Staff Report: Site Plan 820080100 Towns of Tanglewood (Formerly Kushner Property)

REPORT DATE: August 21, 2008

APPLICATION DESCRIPTION: Construct 36 one-family attached townhouses, including 5 MPDUs in the RT-8 Zone; Located on the east side of Dogwood Drive approximately 900 feet north of Briggs Chaney Road within Fairland Master Plan area.

DATE: MAY 29, 2008
TO: ROBERT GOSS, GLW
FROM: MARIE LABAW
RE: TOWNS OF TANGLEWOOD 820080100

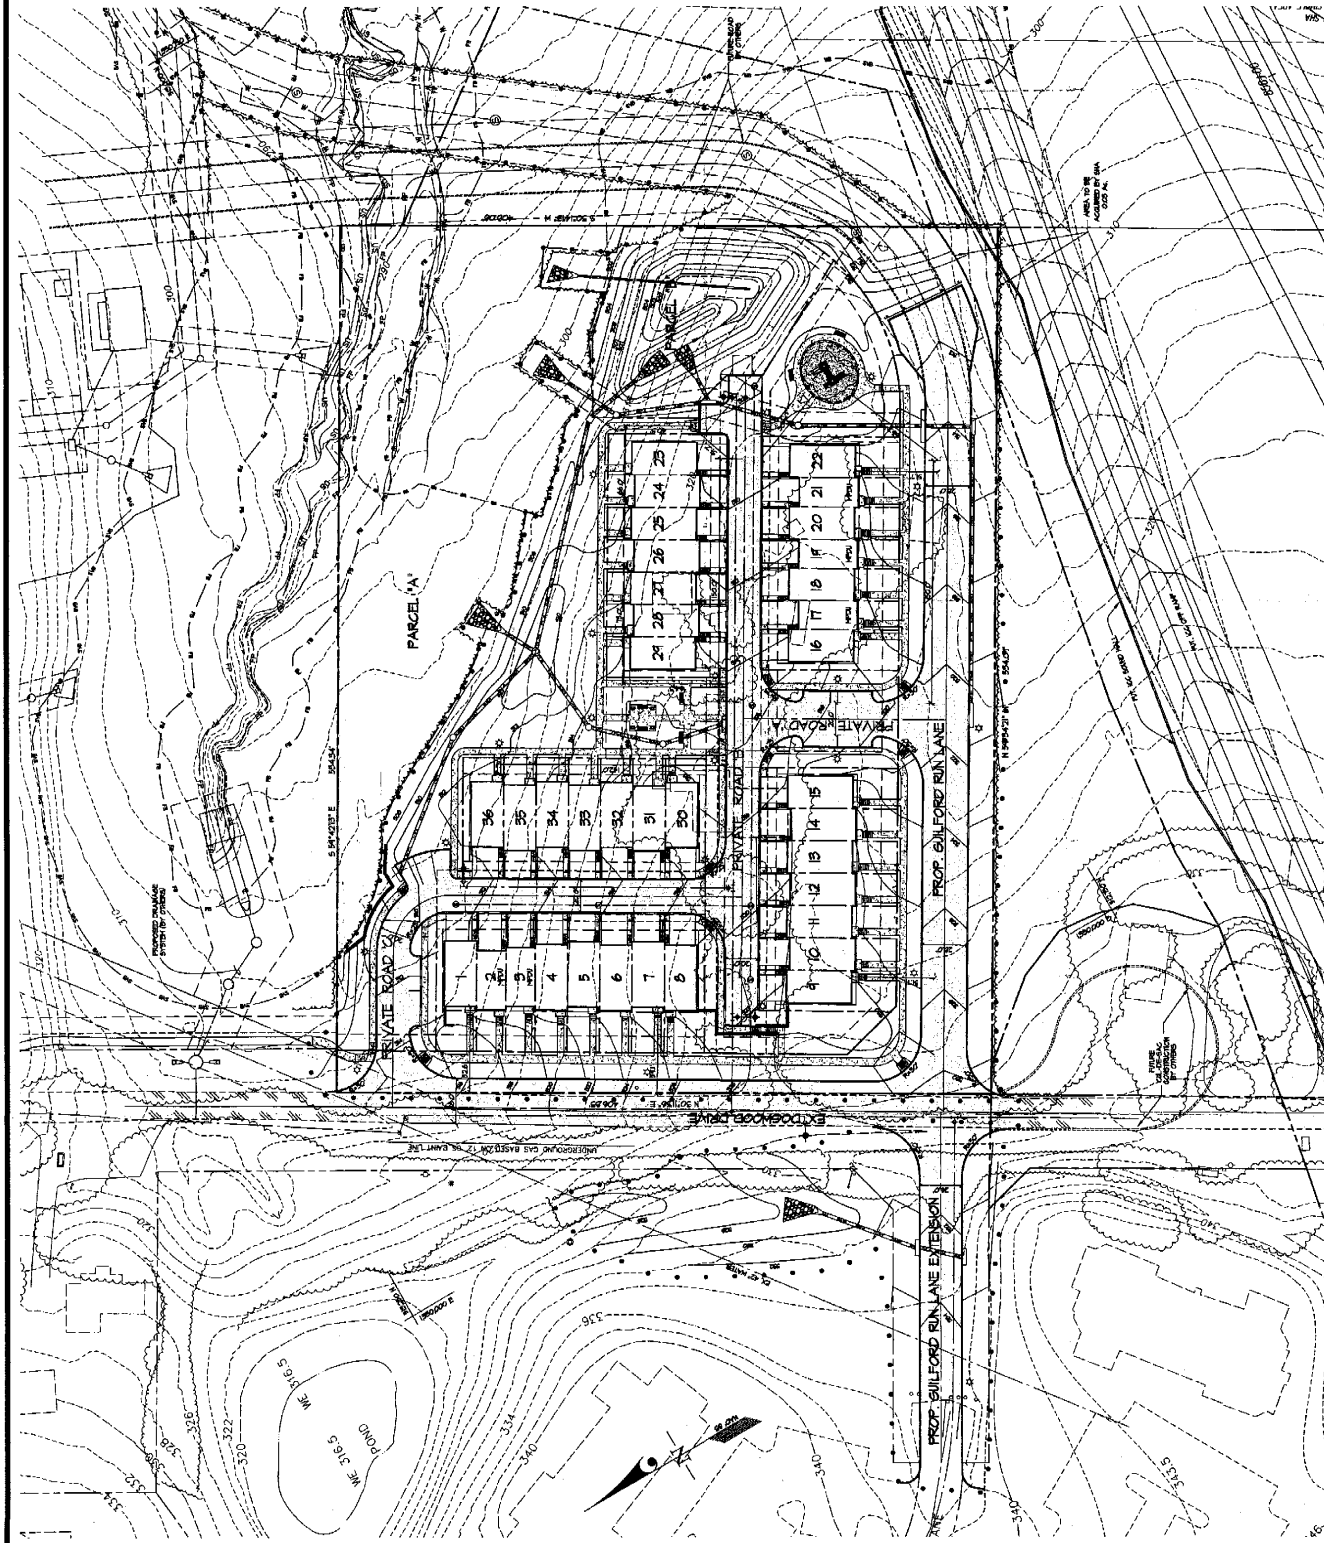
PLAN APPROVED.

1. Review based only upon information contained on the plan submitted **05-07-08**. Review and approval does not cover unsatisfactory installation resulting from errors, omissions, or failure to clearly indicate conditions on this plan.
2. Correction of unsatisfactory installation will be required upon inspection and service of notice of violation to a party responsible for the property.
